**UNION TOWNSHIP BOARD OF TRUSTEES
JANUARY 14TH, 2025 MEETING**

MAJOR AMENDMENT

**EVANS ENGINEERING, Applicant
4375 Ferguson Drive / Parcel ID # 413215E129.**

Staff Report: CASE # 17-86-Z

LIGHTING SITE PLAN	SCALE 1"=20'-0"	DESIGNER JJ	CHECKED JJ	DATE 11/19/24	SHEET S1
--------------------	-----------------	-------------	------------	---------------	----------

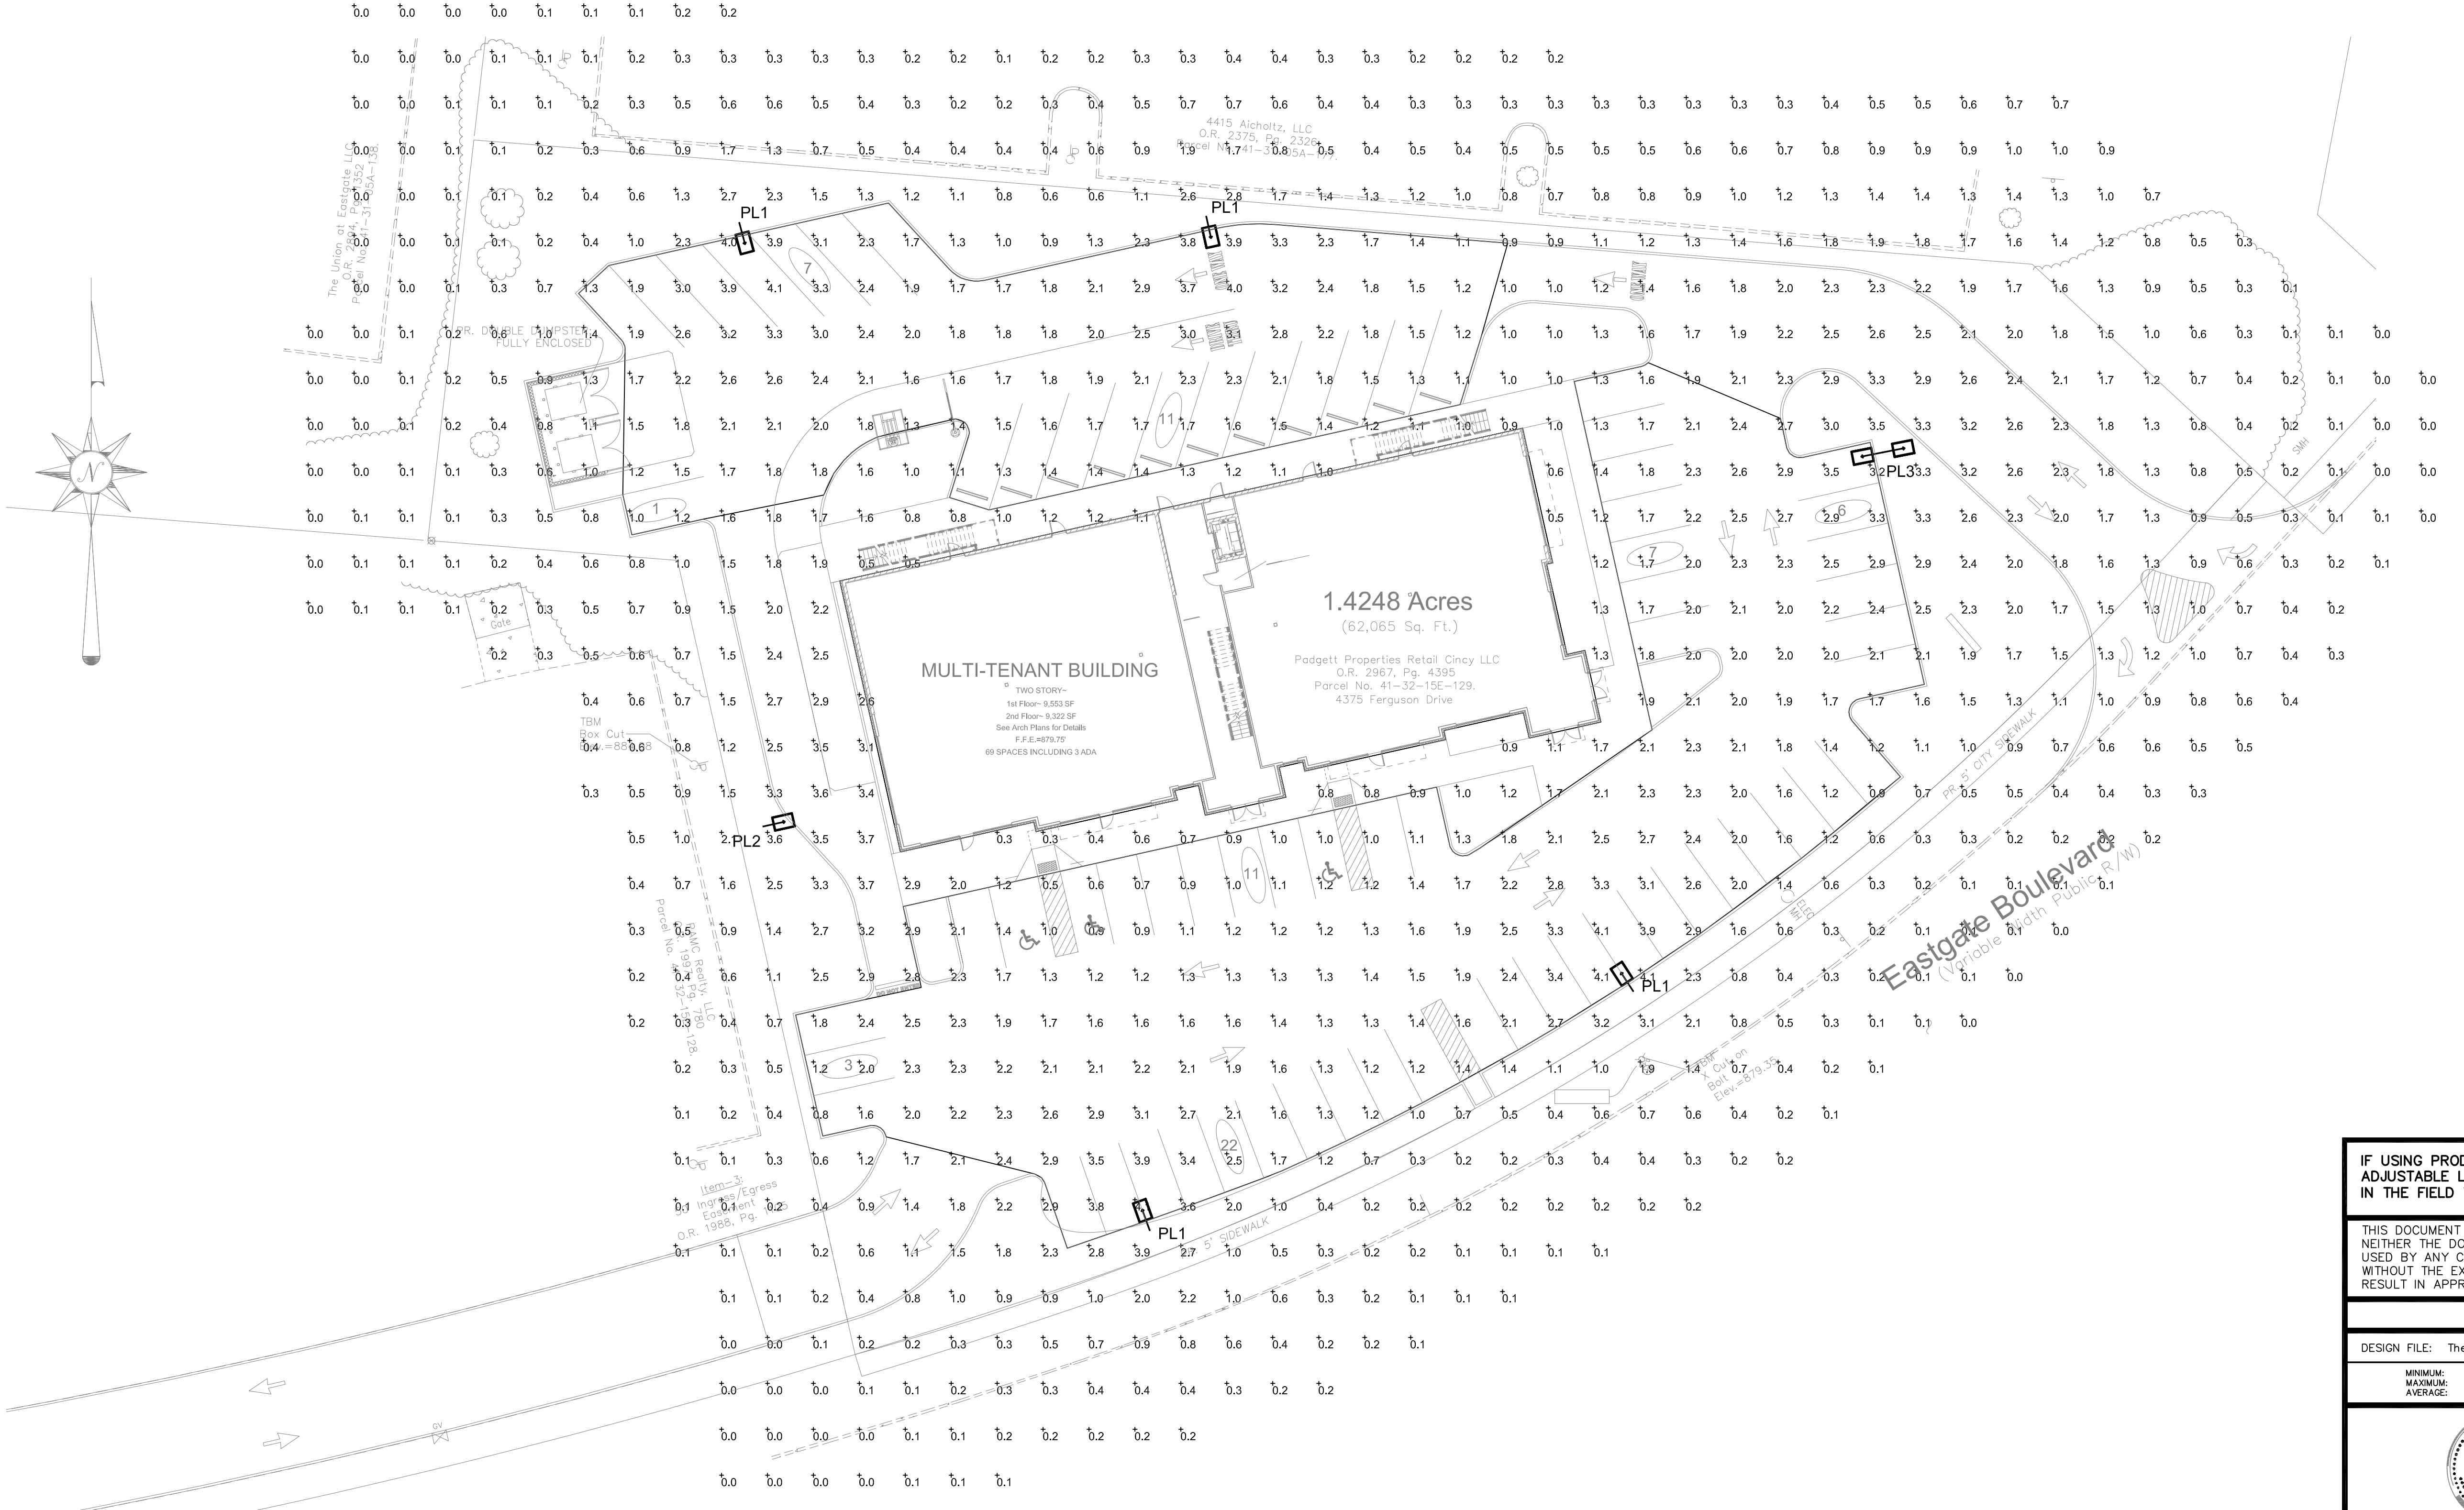
6. A lighting / photometric plan for the proposed site has been submitted. All lighting would need to be noted as “downward directed, dark-sky compliant” and of sufficient intensity to illuminate without projecting onto the adjoining residential property (i.e. less than or equal to 1.0-foot candle at the property lines and road right-of-way). *Details / specs of proposed lighting would be necessary; *however, this is an item that can be addressed administratively by staff.*

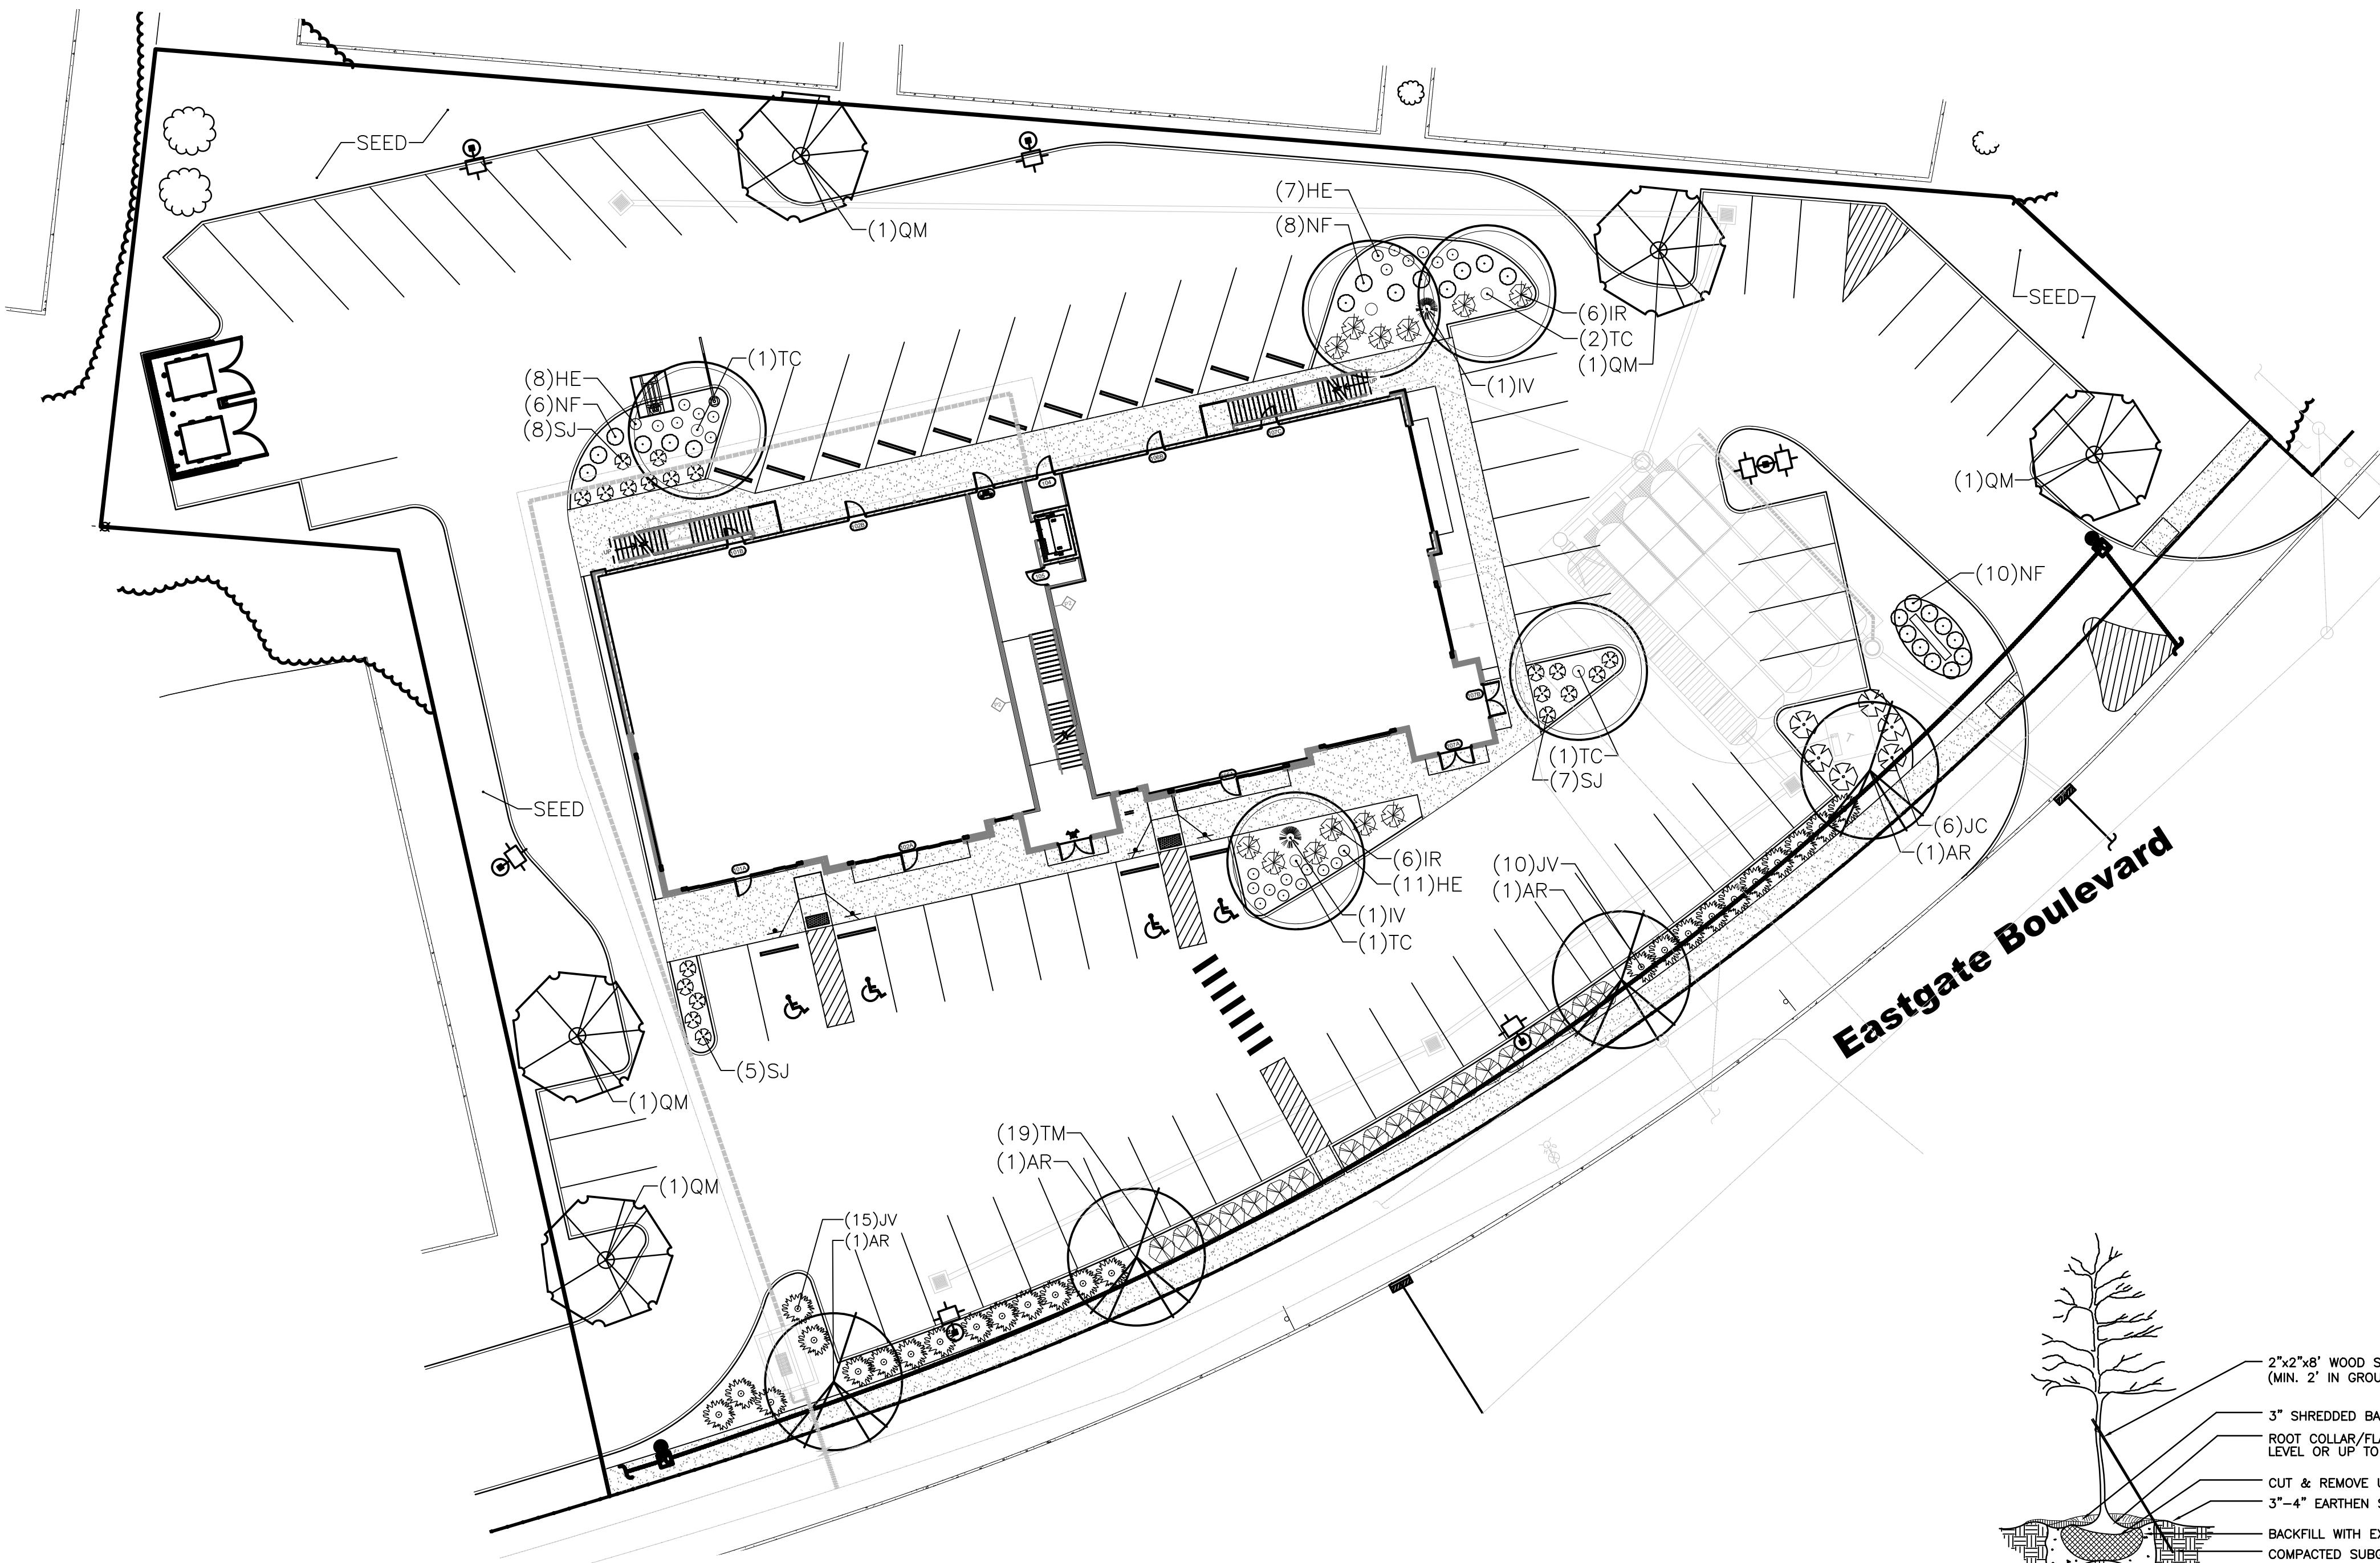
A review of the proposed building elevations appears to show that the principle, visible building elevations will consist primarily of masonry material—with brick and stone veneer(s) and windows comprising most of the structure. Although an initial landscaping plan has been provided, a more detailed plan will ultimately need to be provided to be more consistent with development in the Ivy Pointe Commerce Park area.

3. The Applicant would need to provide an enhanced landscaping plan—with street trees added along the frontage and with a vegetative buffer surrounding the proposed dumpster area, *subject to administrative review and approval.*
